MAY 16, 2018
BOARD OF COUNTY COMMISSIONERS
ORANGE COUNTY FLORIDA
ADDENDUM NO. 2/IFB NO. Y18-759
ORANGE COUNTY PORTER TRANSFER STATION SITE IMPROVEMENTS

THE REVISED BID OPENING DATE IS MAY 22, 2018

CADD FILE:
 DATE: MARCH 2018
 SCALE: AS SHOWN
 DRAWING NO.
S-10
 SHEET 28 of 34

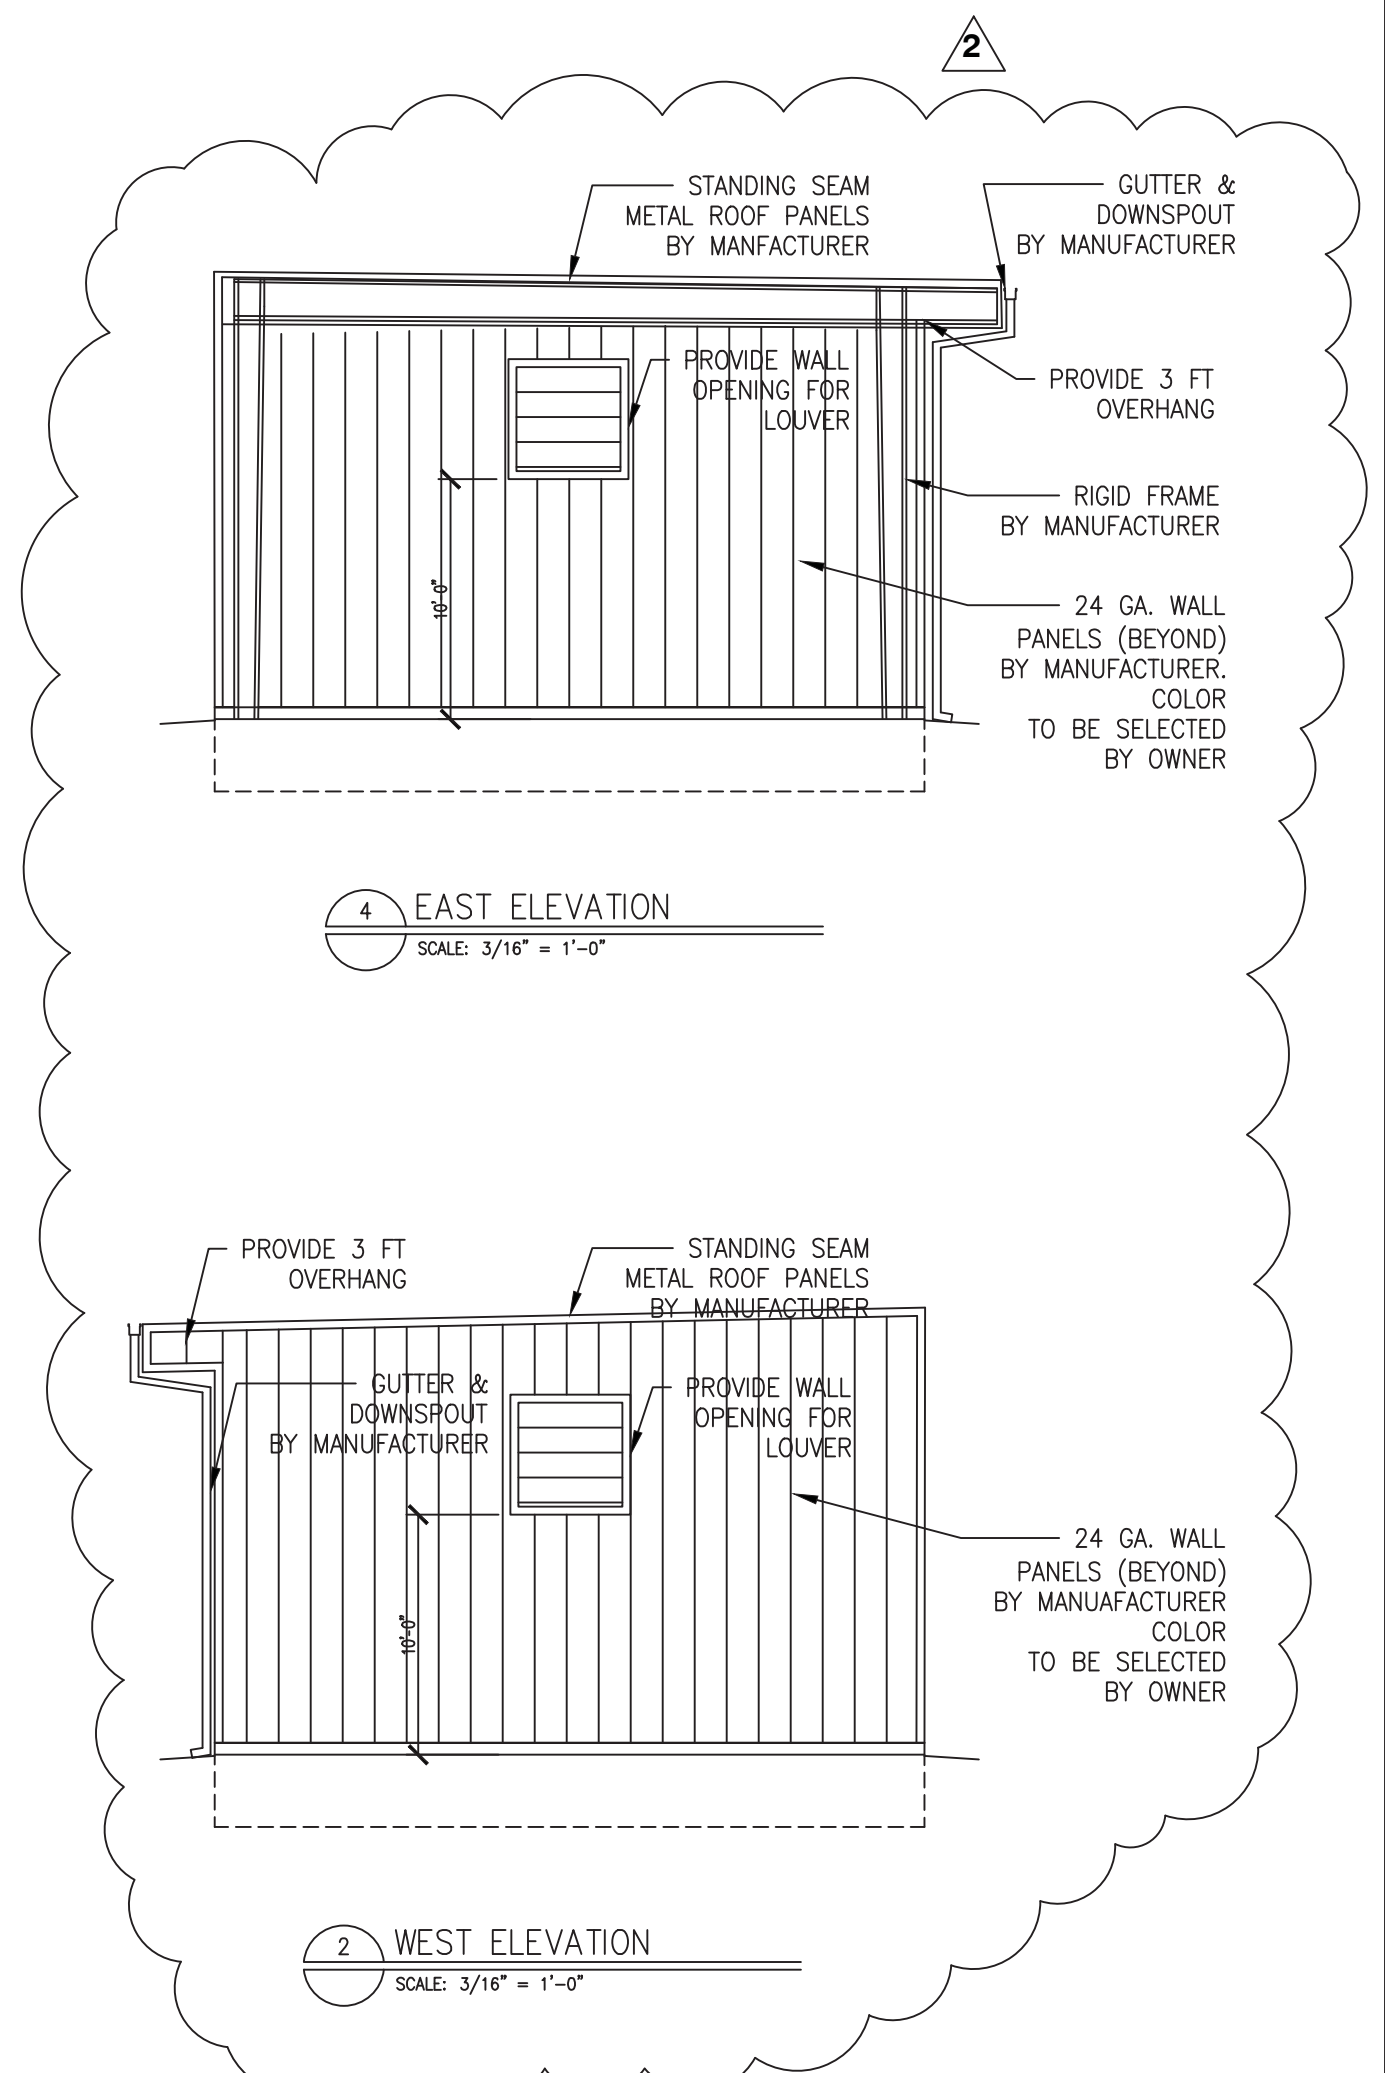
7. **Question:** Detail 5/S10 shows a retaining wall abutting the P.E.M.B. wall panels along the high sidewall of the building. Can the wall panels along the High sidewall be terminated at the top of the retaining wall elevation, 4'-0" AFF?

- Response:** No. The horizontal girts shown on Detail 5 of Sheet S-10 may be re-spaced or adjusted for ease of wall panel construction.
8. **Question:** Please confirm 3'-0" roof overhang at high sidewall extending into Truck Transfer Trailer Bay.

- Response:** Refer to the updated Drawing S10. The roof overhang shall not extend into the trailer bay. The roof shall extend 3'-0" from the south side of the building. There shall be no overhang over the Transfer Trailer Bay side.

CHK. BY	DESCRIPTION	DATE	REV
	REVISED IN RESPONSE TO BID ADDENDA 2	5/14/18	1
			2
			3
			4
			5
